| Project Name | DISCOVERY POINT WOLLI CREEK STAGE 1 |
| Drawing Title | EARLY WORKS BULK EARTHWORKS SECTIONS - SHEET 1 |

Drawing Title
STAGE 1
STORMWATER PLAN LAYOUT

Re: Discovery Point Stage 1 – Proposed Carpark Under Neighbourhood Park

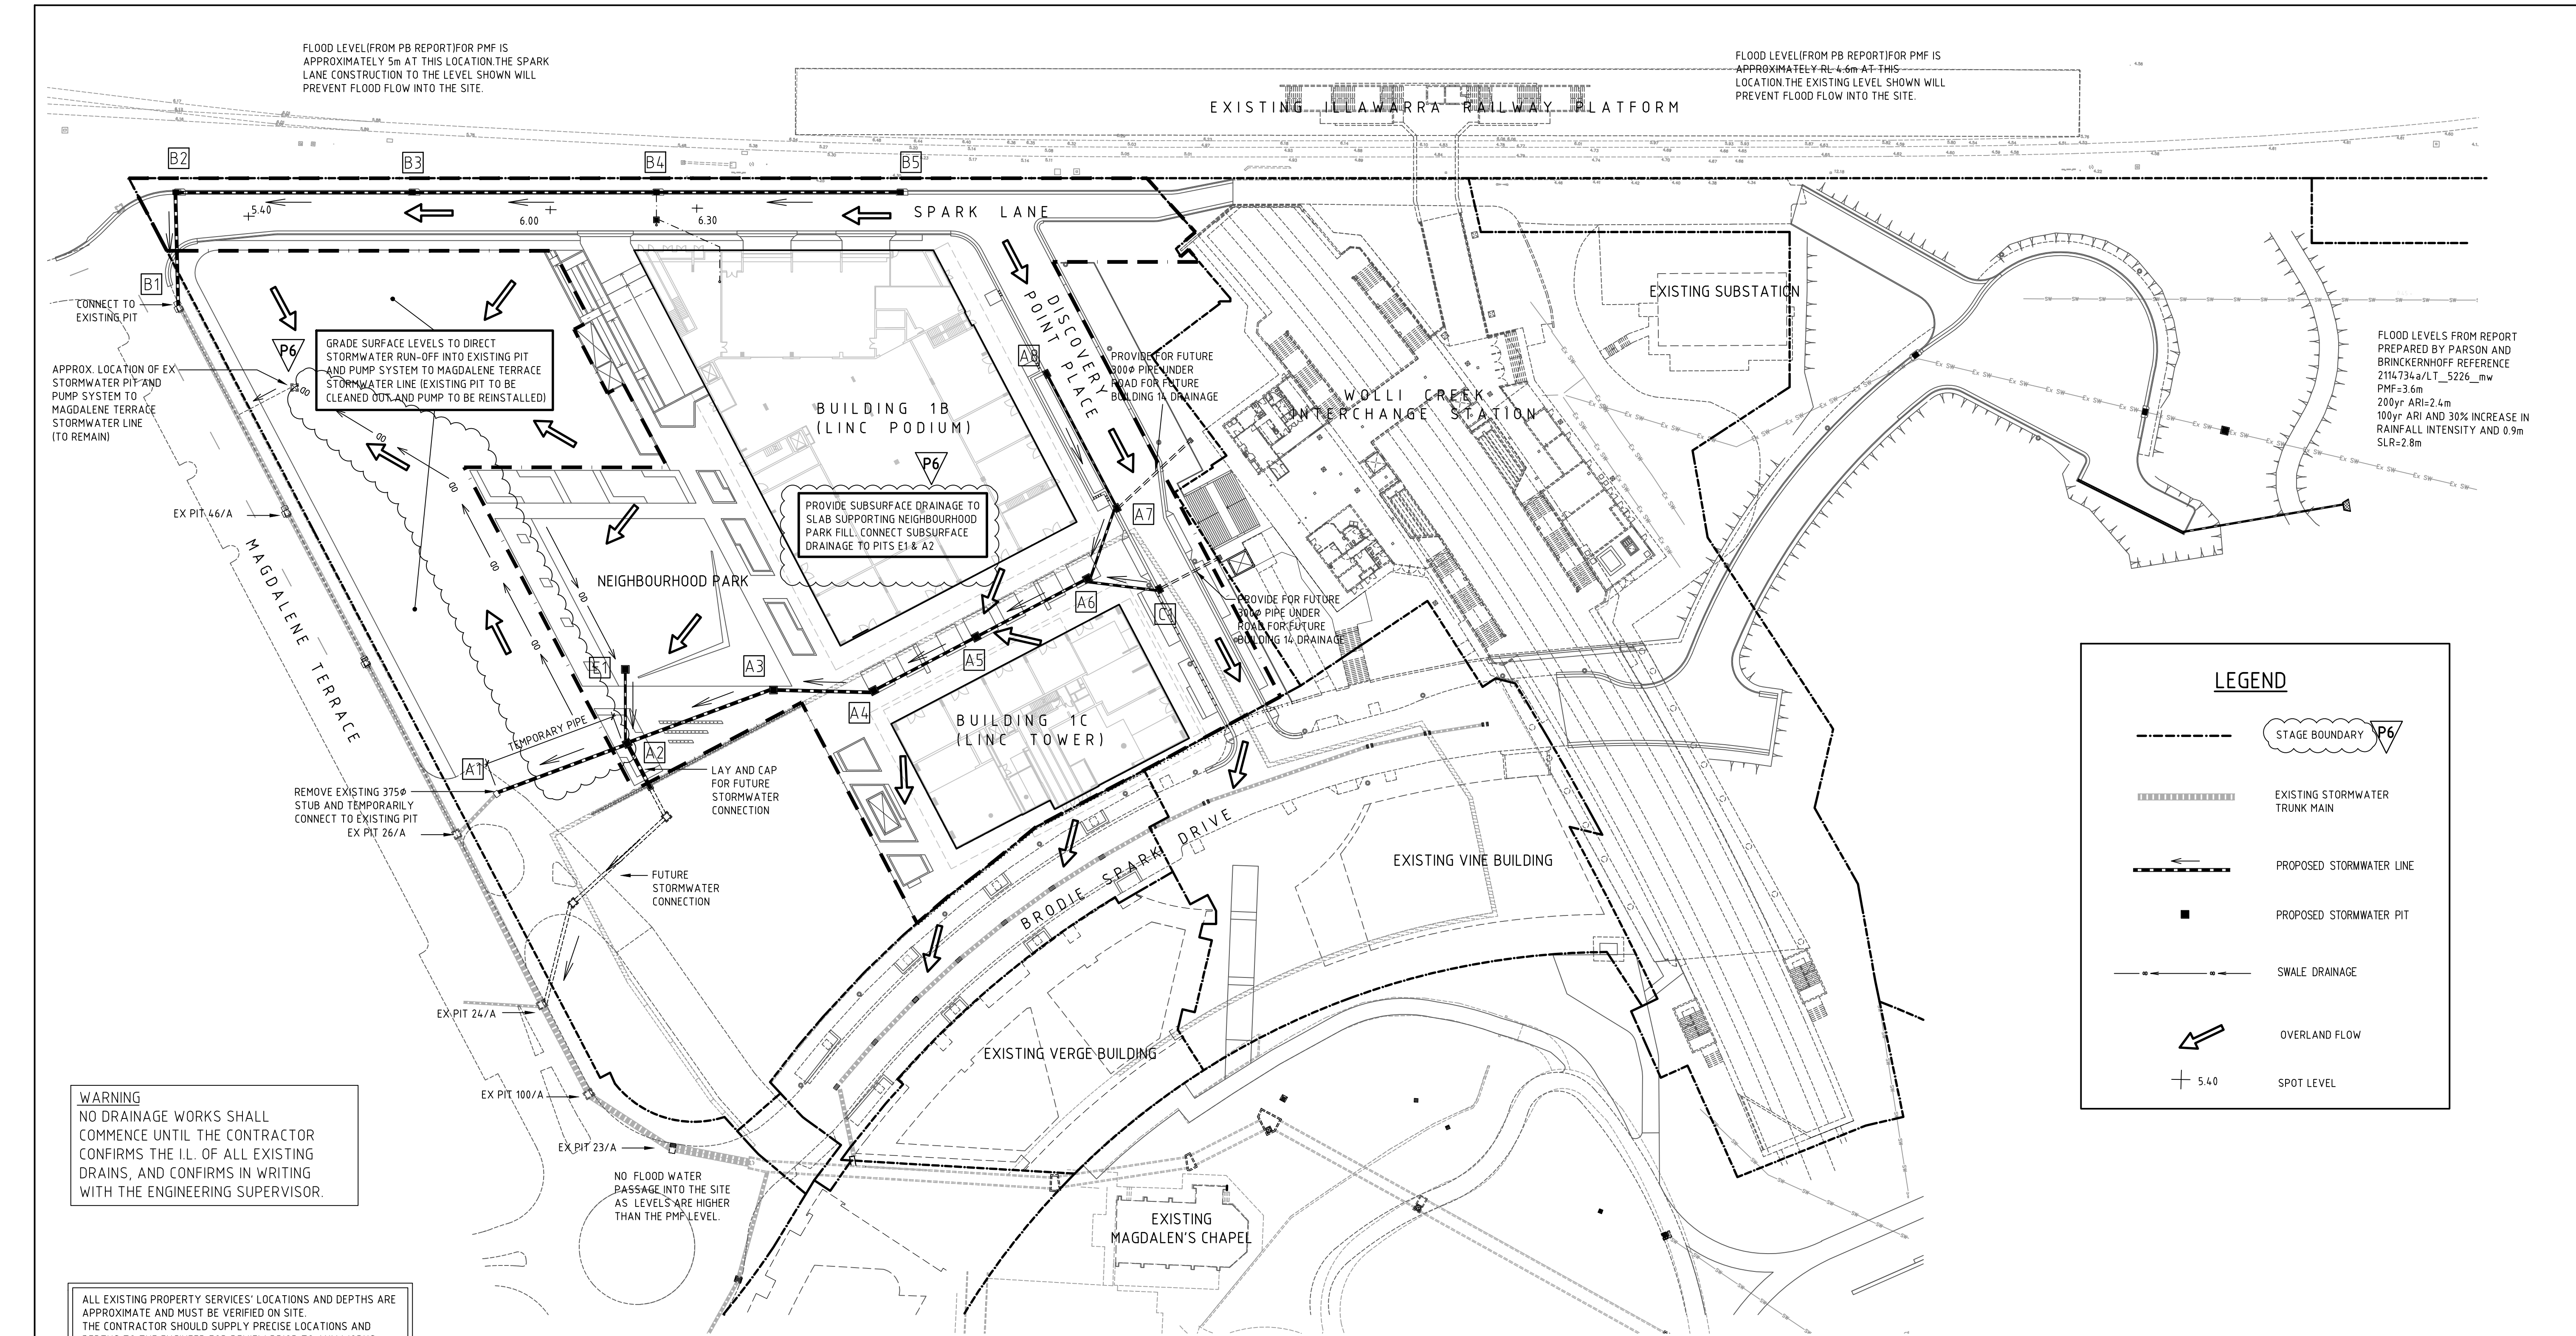
| B | SECTION 1 AMENDED TO SUIT NEW EXTENT OF EARTHWORKS | 17.08.12 | JF | SN |
